Product information - BMW brake pads | HELLA

8DB 355 009-271 / 8DB 355 015-391

New allocation of the brake pads

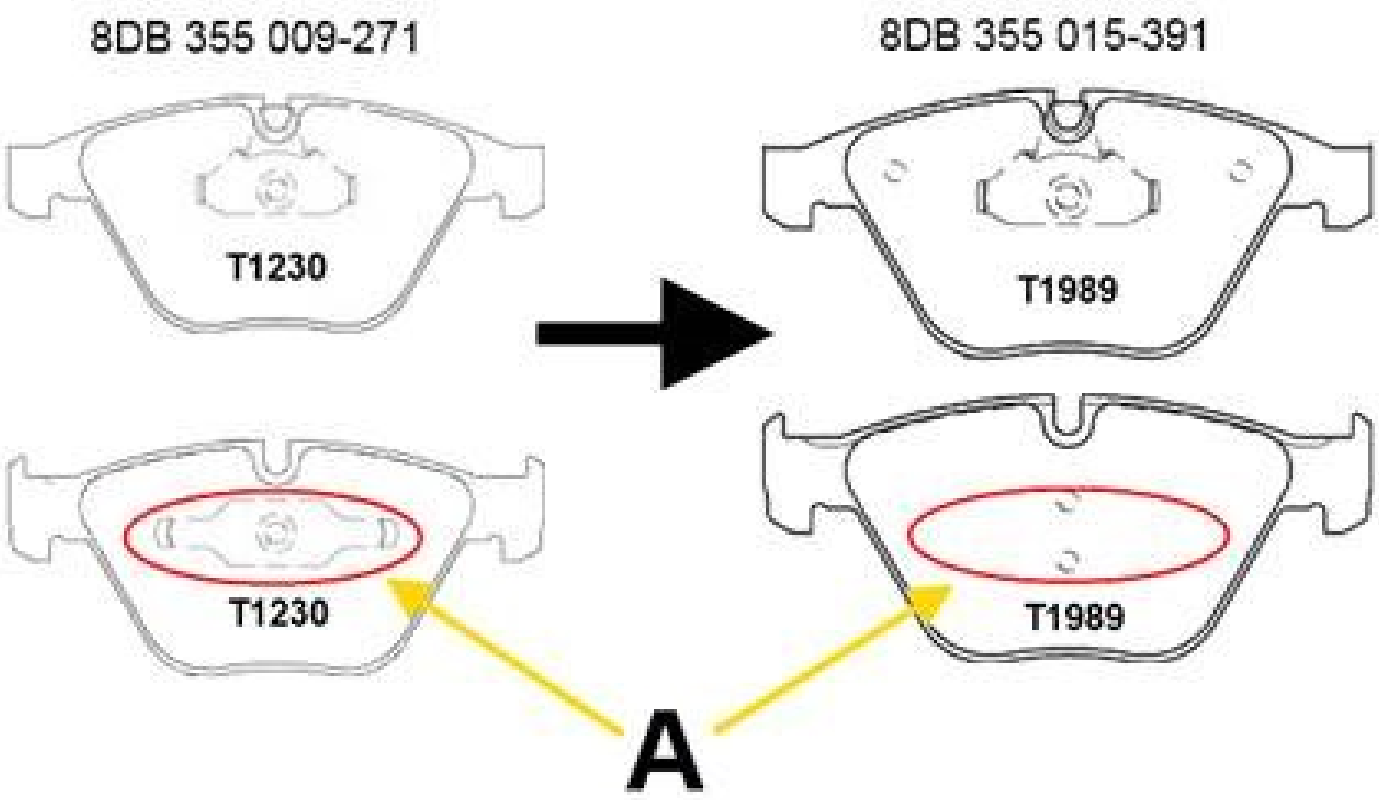
The difference between both brake pads is the missing retaining spring (A) on the brake pad 8DB 355 015-391 / T1989 on the fist side.

Brake pads 8DB 355 009-271 / T1230 shall still be used for the M models of the 1 series (E82) and 3 series (E90-91).

All other models are now covered by 8DB 355 015-391 / T1989. 8DB 355 015-391 / T1989 can also be retroactively used for all vehicles linked.
